Revisions				
P01	28.06.16	PLANNING ISSUE	AE	PY
P02	14.07.16	REVISED PLANNING ISSUE	KI	PY
P03	09.03.17	PLANNING AMENDMENT SUBMISSION	NH	LP

Project
 TWICKENHAM STADIUM
 EAST STAND EXTENSION

Drawing title
 LEVEL 7 PROPOSED ROOF GA PLAN

Drawing number
 118

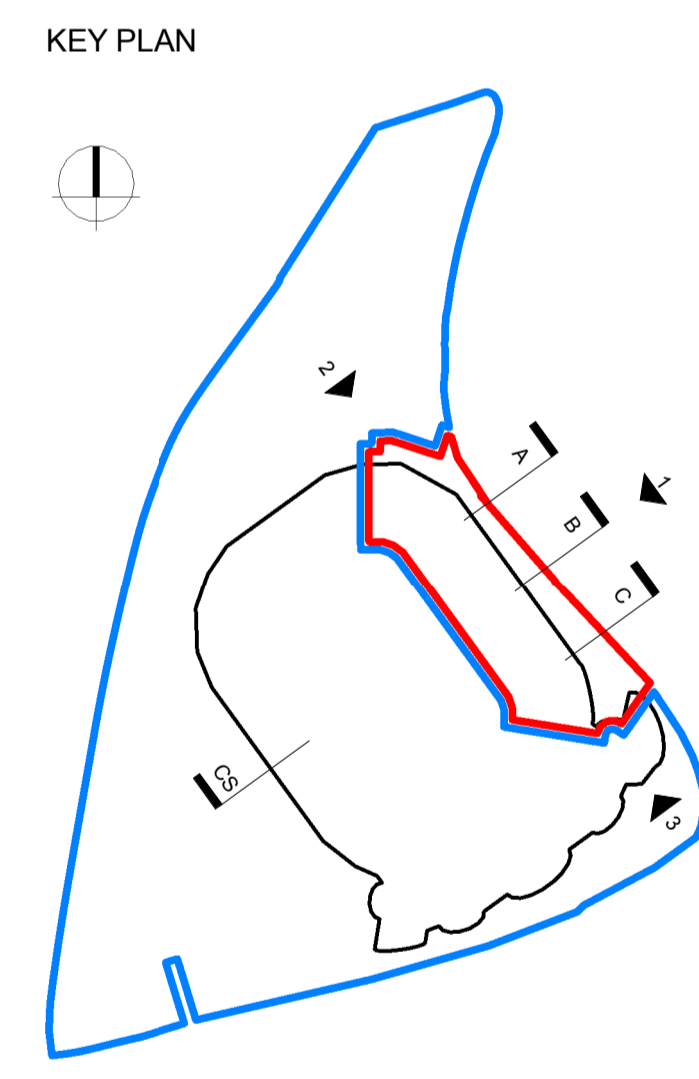
PLANNING AMENDMENTS	
A	GENERAL AMENDMENTS TO THE SOUTH END. INCREASED SHINGLES CLADDING AREA AND CURTAIN WALL REDUCED ACCORDINGLY.
A1	REDUCED MASSING AND REVISED INTERFACE WITH THE SOUTH STAND.
A2	PPC LOUVRES LOCATED TO THE BOWL SIDE HAVE BEEN OMITTED.
B	CURTAIN WALL SETTING OUT REVISED GENERALLY. SILICONE JOINTS TO TRANSOMS AND MULLION REPLACED WITH CAPPED SYSTEM. LEVEL 04 PPC LOUVRES SETTING OUT & HEIGHT REVISED. MONORAIL FOR ABSEILING REMOVED.
C	GENERAL AMENDMENTS TO THE CENTRAL ELEVATION CANOPY AT LEVEL 5A REVISED GENERALLY AND STANDING SEAM REPLACED WITH SINGLE PLY MEMBRANE. SUPPORT COLUMNS TO ROOF CANOPY REVISED. SQUARE FASCIA TO ROOF EDGE. LEVEL 5A GLAZED SCREEN EXTENDED IN HEIGHT AND PPC LOUVRES INCLUDED AT LOW LEVEL.
D	INCREASED SHINGLES CLADDING AREA AND CURTAIN WALL AREA REDUCED ACCORDINGLY. FOUR VERTICAL FINNS REMOVED.
D1	PORCELAIN PANELS WITH SLOTTED HOLES FOR VENTILATION REPLACED WITH PPC LOUVRES. PANELS OMITTED.

D2	EXPRESSED HORIZONTAL PATTERN TO PORCELAIN CLADDING.
D3	GENERAL AMENDMENTS TO THE NORTH END PORCELAIN CLADDING REPLACED WITH PPC ALUMINIUM CLADDING.
E	GREEN WALL TO THE NORTH END EXTENDED AND PPC LOUVRES REMOVED.
E1	INCREASED SHINGLES CLADDING AREA AND CURTAIN WALL REDUCED ACCORDINGLY.
E2	FENCELINE, GATE AND PERIMETER COLUMNS SETTING OUT REVISED.
E3	CANOPY TO TURNSTILES REVISED.
F	PORCELAIN PATTERN CHANGED FROM HORIZONTAL TO VERTICAL.
F1	PORCELAIN PANELS TO THE SOFFIT OF THE ARCH REPLACED WITH PPC ALUMINIUM PANELS. PORCELAIN PANELS SETTING OUT REVISED.
F2	ROOF TO LEVEL 5A (NORTH END) EXTENDED.
G	GLAZED SPANDREL PANELS REPLACED WITH METAL SPANDREL PANEL. PORCELAIN PANELS REPLACED WITH PPC ALUMINIUM CLADDING.
H	PPC LOUVRES INCLUDED FOR MECHANICAL VENTILATION.
I	
J	
K	
L	
L1
